LIGHTNING

SERVICE BULLETIN No.008

PRODUCT MODEL	: CCS Lightning
BULLETIN TYPE	: Product Update
MANUAL / SECTION	: N/A
PARTS LIST REVISION	: N/A
EFFECTIVE DATE	: June 11, 2007
SUBJECT	: VIBRATION ISOLATOR REPLACEMENT
UNITS AFFECTED	: Units purchased prior to June 2007
PARTS AFFECTED	: 1063742 & 1058585 vibration isolators
TERMS & CONDITIONS	: N/A

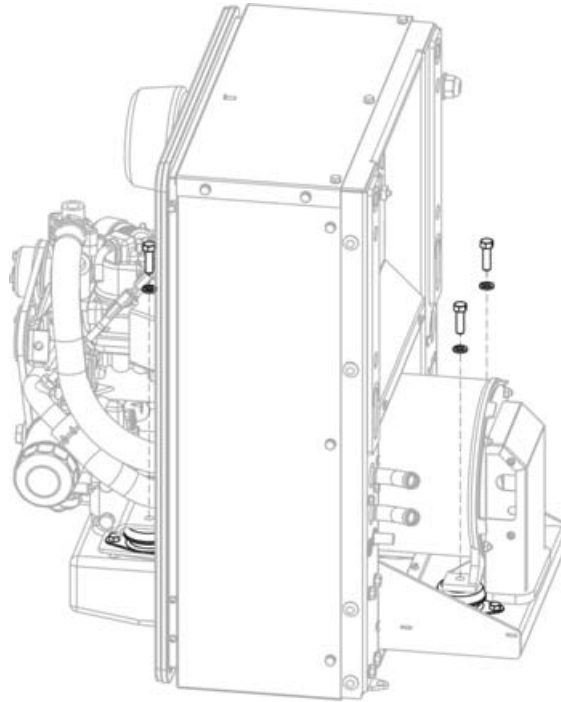
3. Remove 8 screws (1/4-20) and washers from alternator cover, then remove alternator cover and set aside.

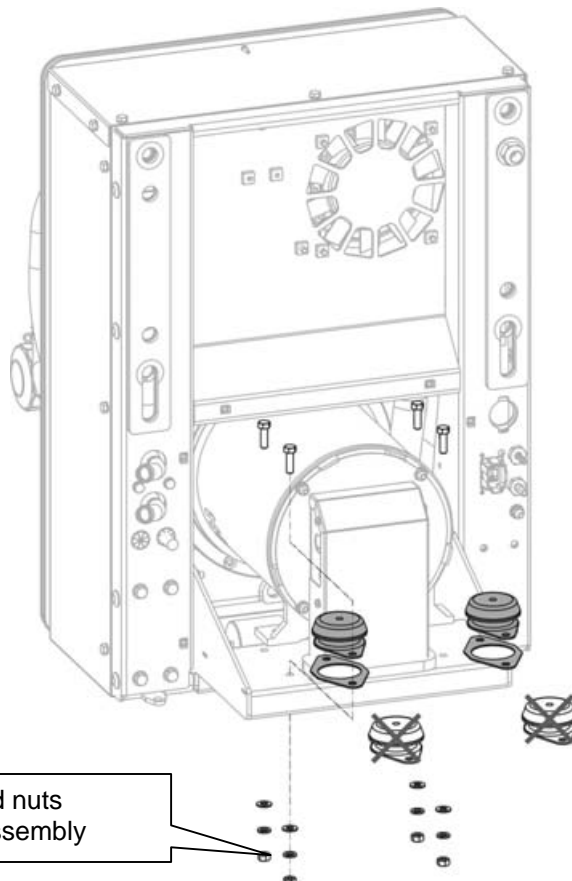
4. Place pry bar under isolator cap and push up to ensure isolator does not rotate (or use vise-grip pliers to hold the isolator cup). Remove centre isolator mounting bolts (M10, 17mm hex head) and lock washers from all 4 isolators.

Newer versions have weld nuts installed into the cradle assembly

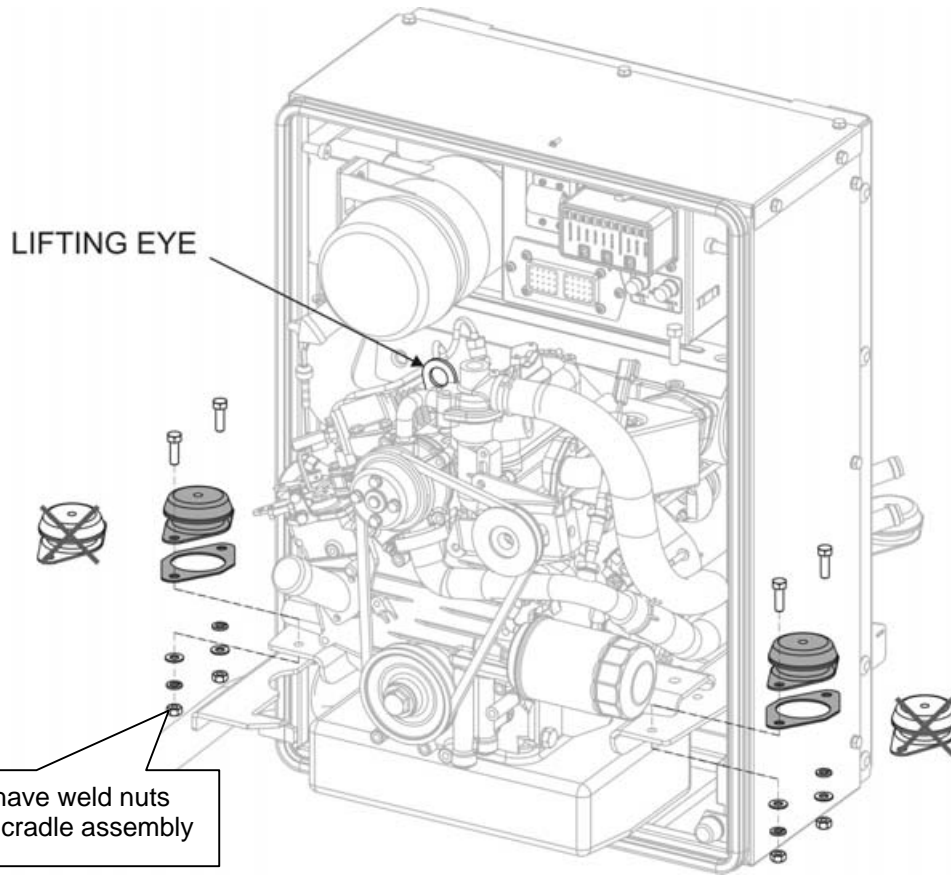
5. Remove isolator to cradle mounting bolts, washers and nuts (5/16-18) and set aside for future use.
6. Using a spacer block to support the Alternator Assembly, remove the rear isolators.
7. Install a spacer plate (1068788) and isolator (1068698 – RED DOT) under each side of the Alternator Bearing Housing. These parts are included in 1070346 KIT, VIBRATION ISOLATOR, REAR, CCS/ITEC.
Remove the spacer block under the alternator assembly.
8. Loosely install the isolator to cradle mounting bolts, washers and nuts (5/16-18) until hand tight.
